NEW! ULTIMATE SLIDE BOLT ASTRAGAL WHAT HAS CHANGED?

The NEW! Ultimate Slide Bolt Astragal is one of two alternatives to the previous Ultimate Astragal design. With an 18" sliding bolt featuring a unique ratchet mechanism and the Floating Boot System, the Ultimate Slide Bolt Astragal provides smooth operation, enhanced security and superior sealing.

Form# USBOVN-17

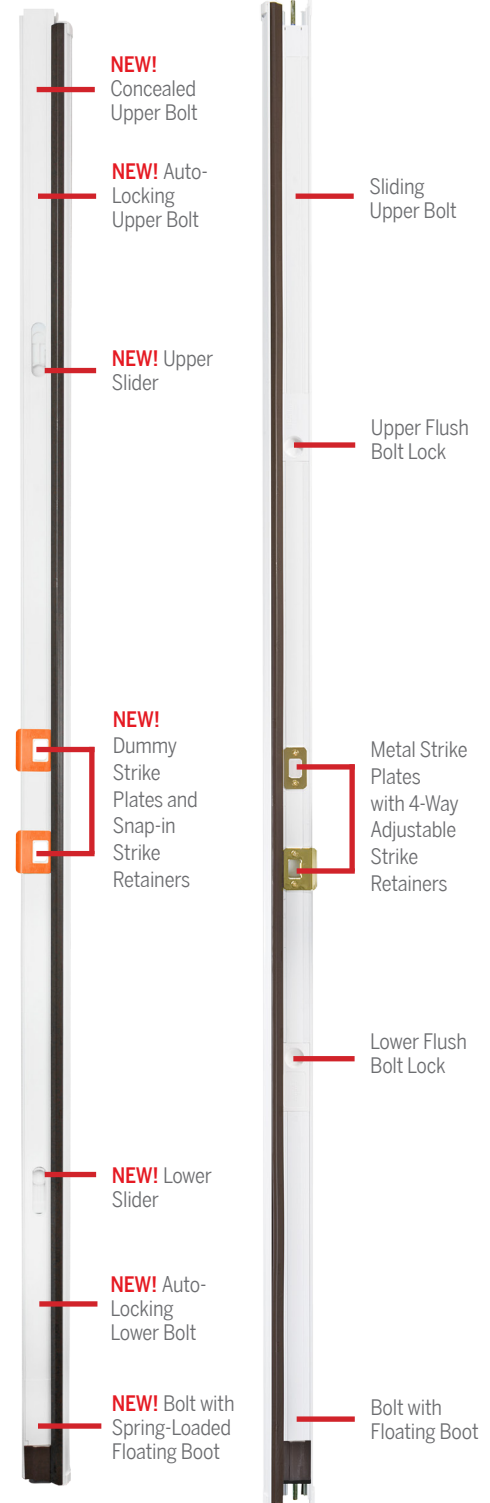
OLD: The upper bolt was visible, resulting in unsightly gaps between the bolt and the trim strip when the bolt was engaged.

NEW: The upper bolt is concealed by the trim strip and features a clean cutout to operate the bolts.

OLD: Bolts required removal for installation.

NEW: With new design, bolt removal is no longer required.

OLD: Sliding bolt required an additional step to lock.

NEW: Sliding bolt now features a unique ratchet mechanism that auto-locks to secure the door unit.

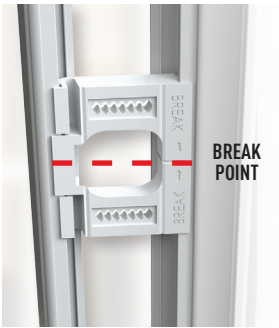
OLD: Metal Strike Plates were pre-installed on the astragal, which were often replaced to match final hardware.

NEW: The Ultimate Slide Bolt Astragal now features Dummy Strike Plates intended for replacement.

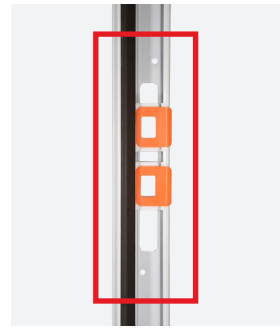
OLD: Resizing strike retainers required cutting and additional tools.

NEW: Without additional tools, strike retainers are easy to remove and resize using built-in break points.
